June 12, 2025
Updated June 17, 2025
ES-9607.02

**Subject: Response to Review Comments
 Cheshire Property
 7615 East Mercer Way
 Mercer Island, Washington**

As requested, Earth Solutions NW, LLC (ESNW) has prepared this response to review comments letter for the subject project. This response letter addresses city of a city of Mercer Island review comments in the referenced review letter. This update includes a review of the latest submittal plans.

LIQUEFACTION ANALYSIS

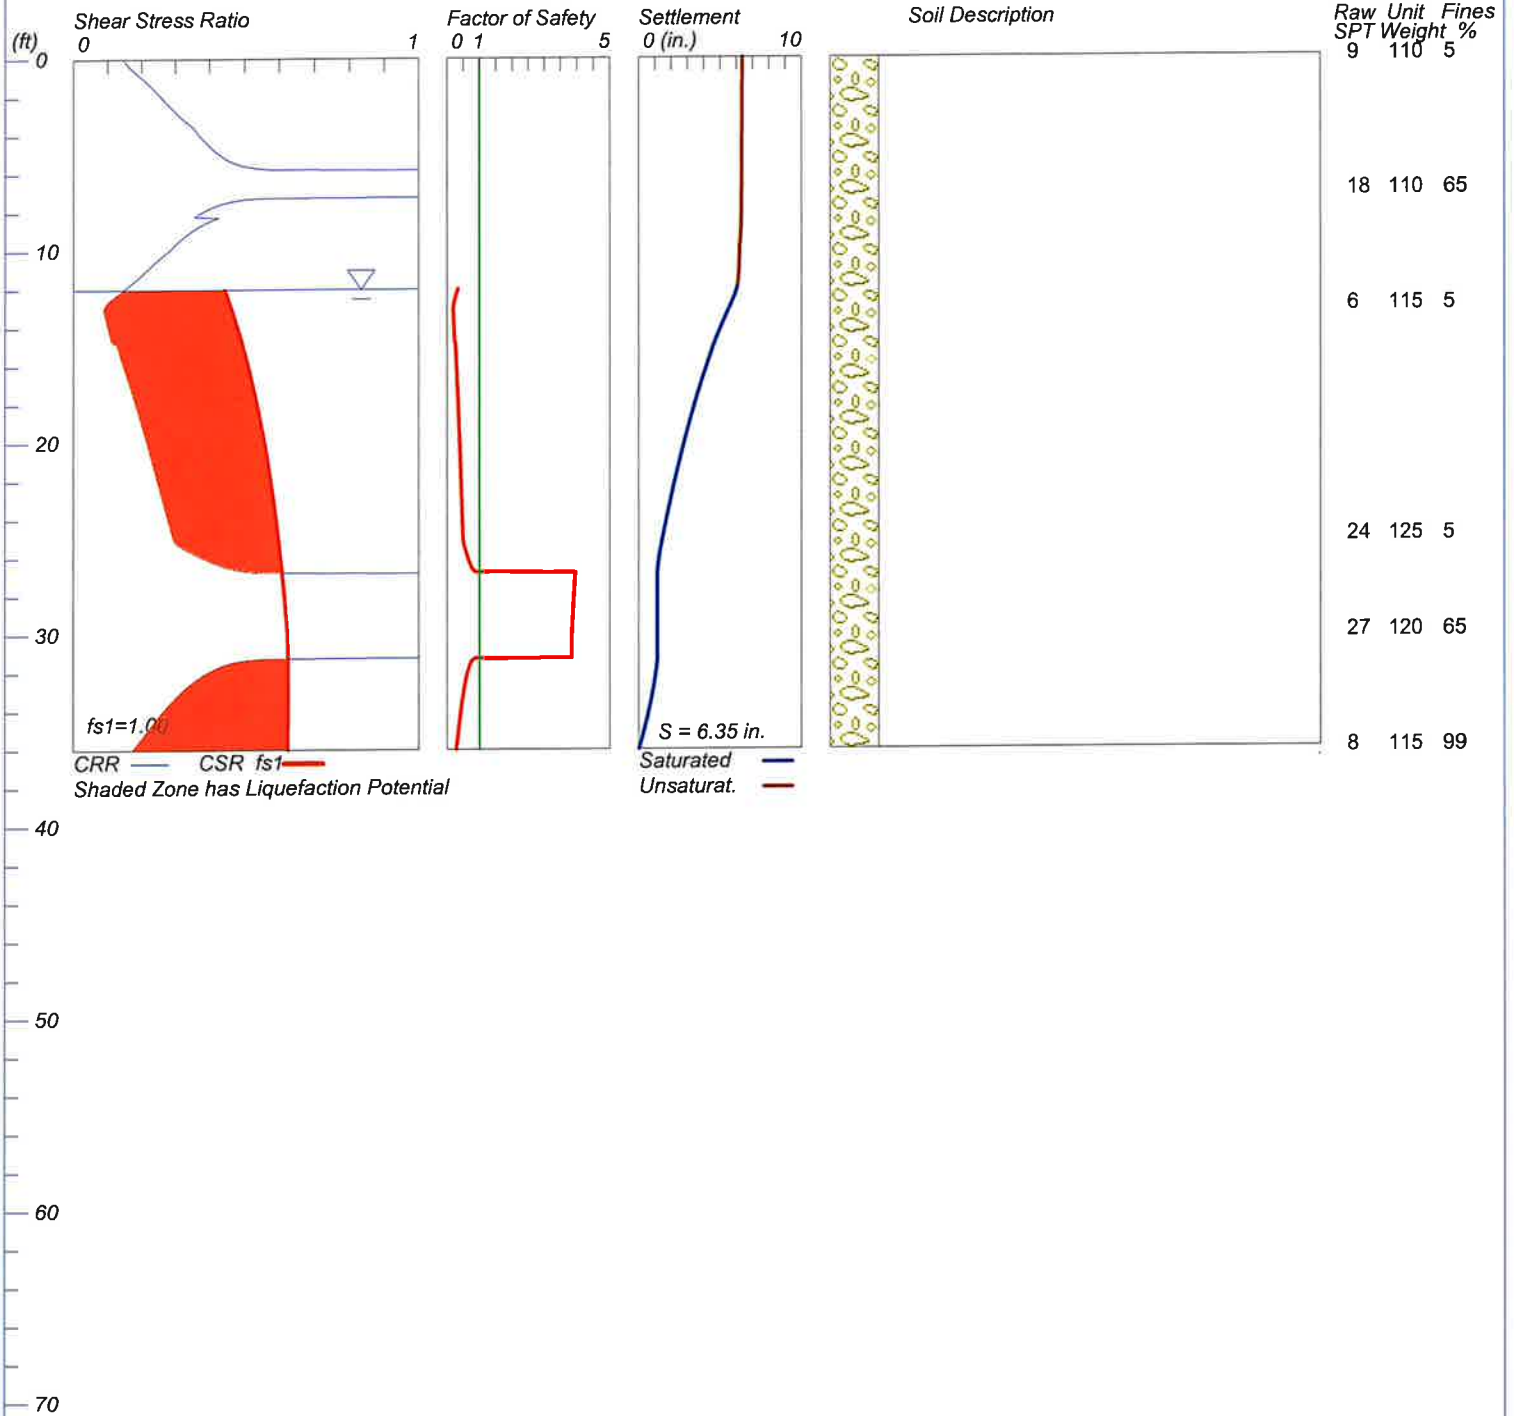
9. *Please assess the potential for liquefaction at the site and estimate post- liquefaction settlement, lateral spreading or flow failures as required by IBC using a peak ground acceleration associated with a 2% probability of exceedance in 50 years earthquake. Please include liquefaction assessment calculations, any post- liquefaction settlement calculations, residual strength determinations and associated stability analyses and/or lateral deformation calculations for review.*

Included as an attachment. The groundwater conditions on this slope are highly variable and discontinuous, as are the soil gradations. In this respect, while saturated clean sandy soils that are loose may liquefy, the extent of this phenomenon is expected to be discontinuous across the site and may not adversely impact the overall site response as the estimated magnitude suggests. Based on the soil variability on this site, we would expect the effects of liquefaction to be isolated and variable as well. Therefore, overall site or site global effects would likely be discontinuous.
